**COUNTY OF SAN MATEO
PLANNING AND BUILDING DEPARTMENT**

SUBJECT: EXECUTIVE SUMMARY: Public hearing to consider an appeal of the Coastsides Design Review Committee's decision to approve a Design Review Permit, pursuant to Section 6565.3 of the County Zoning Regulations, for the construction of a new 2,612 sq. ft. two-story single-family residence, plus a 433 sq. ft. attached two-car garage on an existing 6,386 sq. ft. legal parcel in the unincorporated El Granada area of San Mateo County (APN#047-092-260).

County File Number: PLN 2018-00104 (Kroll)

PLANTING PLANS

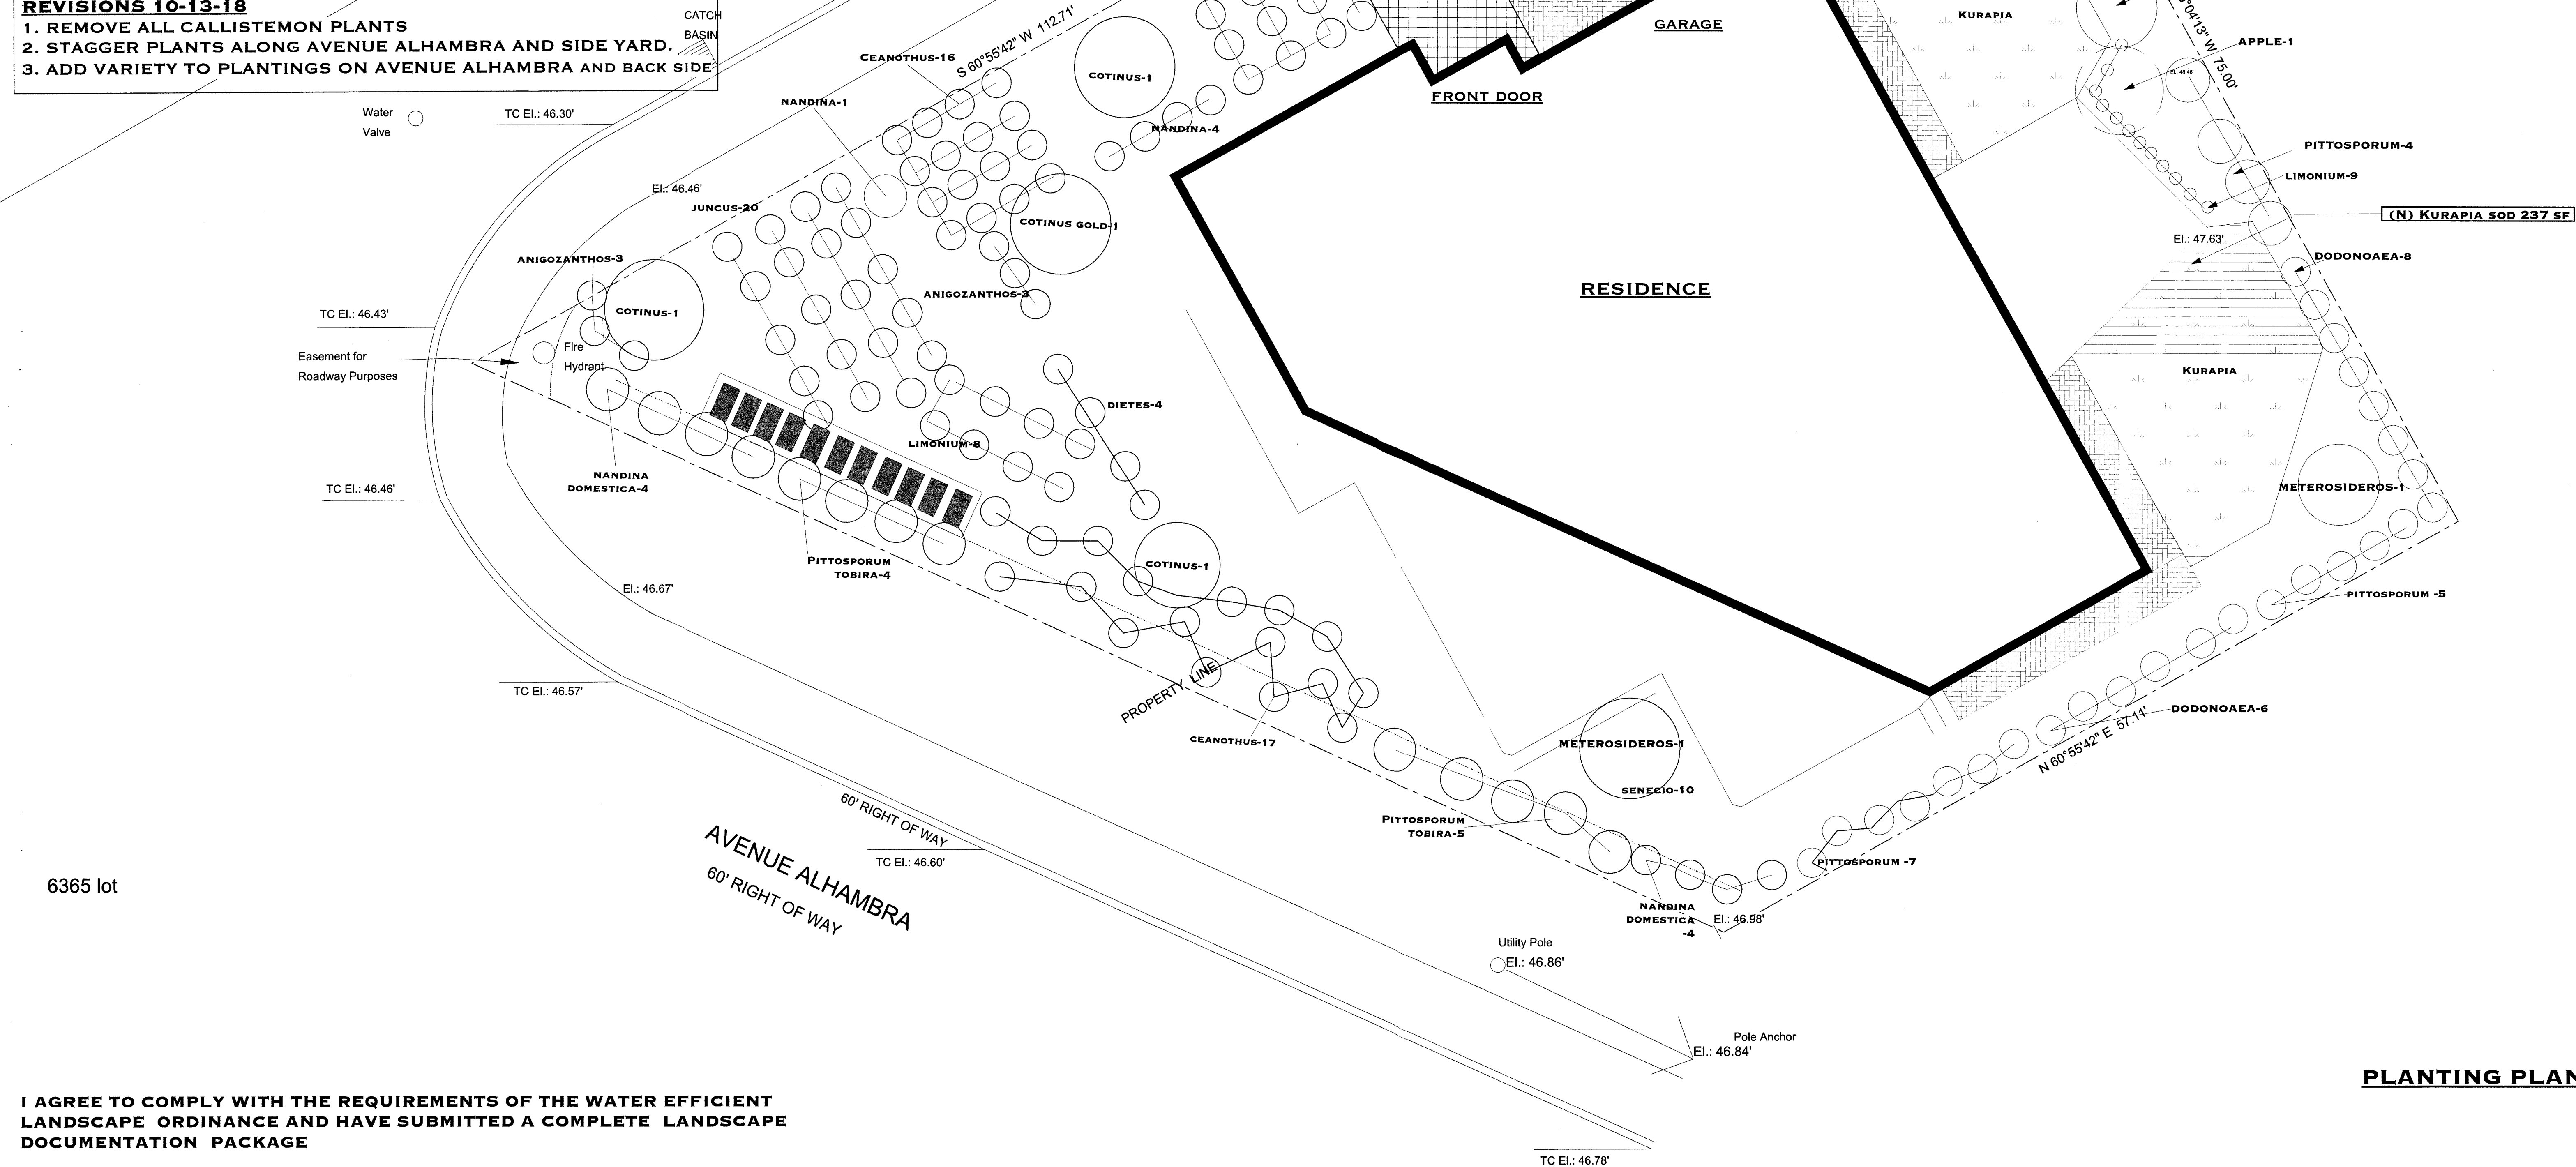
1. REMOVE ALL CALLISTEMON PLANTS
2. STAGGER PLANTS ALONG AVENUE ALHAMBRA AND SIDE YARD.
3. ADD VARIETY TO PLANTINGS ON AVENUE ALHAMBRA AND BACK

Left Elevation

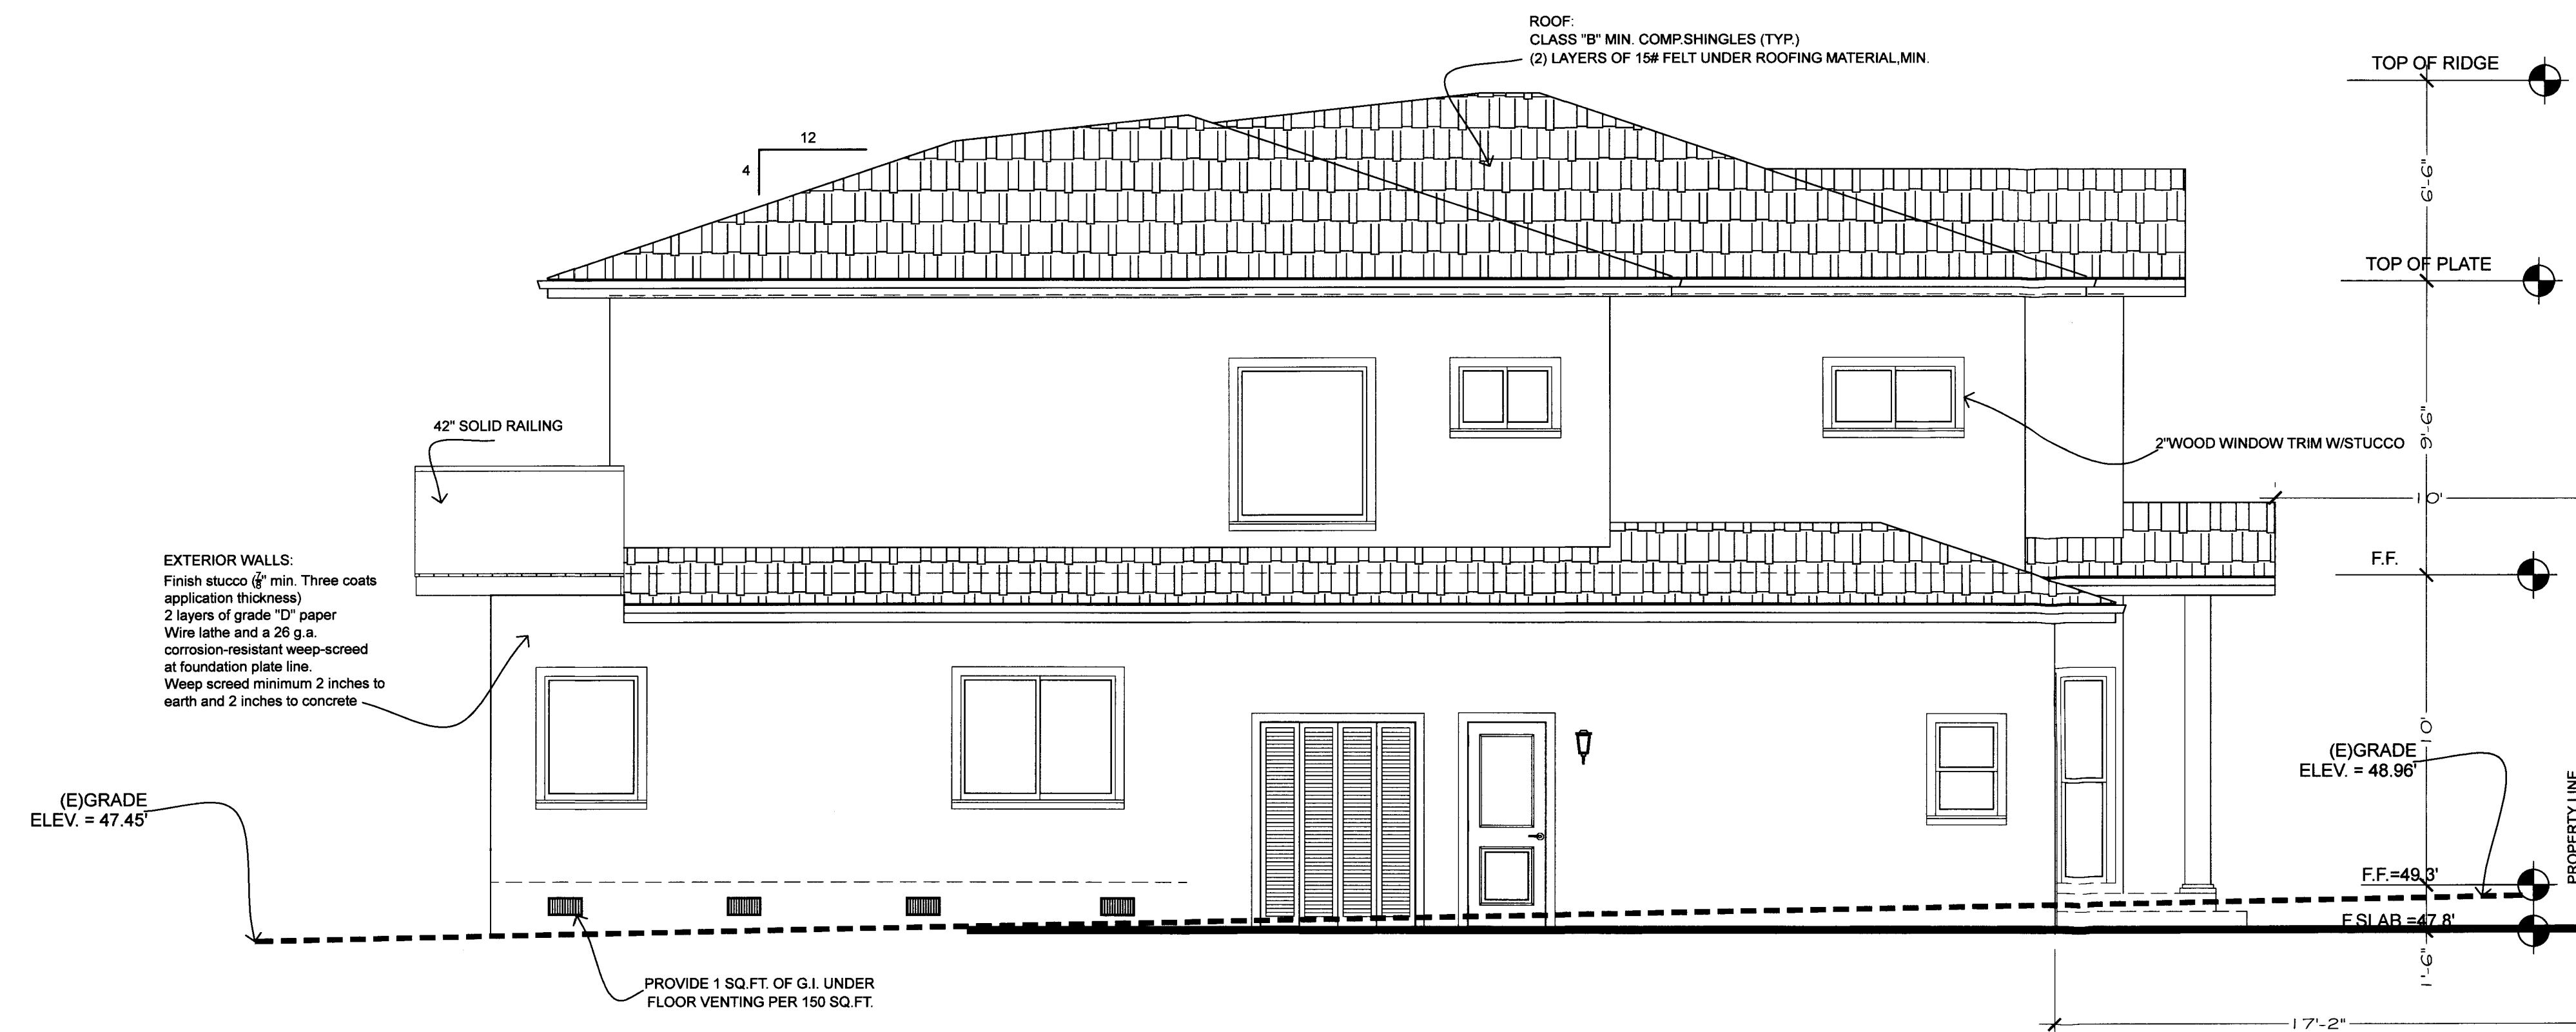
In addition, we think that the Applicant can, in conjunction with a reduction in size of the second story, improve on its attempt to center the second story away from the boundary lines on Vallejo Street. The proposed bedroom on the second story continues to block substantial views when seen from the Project's left elevation (see Sheet A-4) and this can be easily avoided if second story is scaled back modestly.

The long dimension of the Project (i.e., the Project's left elevation as seen on Sheet A-4) lacks meaningful wall articulation and thus, the Project appears more massive and bulky than necessary. Greater wall articulation can be achieved if the Project were not design using maximum front and rear setbacks. We suggest a reduction and additional architectural details to add visual interest.

According to the Project's left elevations (see Sheet A-4), the new Project increases the scope of window coverage which will have negative impacts to the Project's immediate neighbors. For instance, the windows now appear along the entire length of the first floor, and are generally larger in size. It does not appear that the Applicant has made any attempt to use appropriate architectural solutions such as clerestory windows or obscure glass.
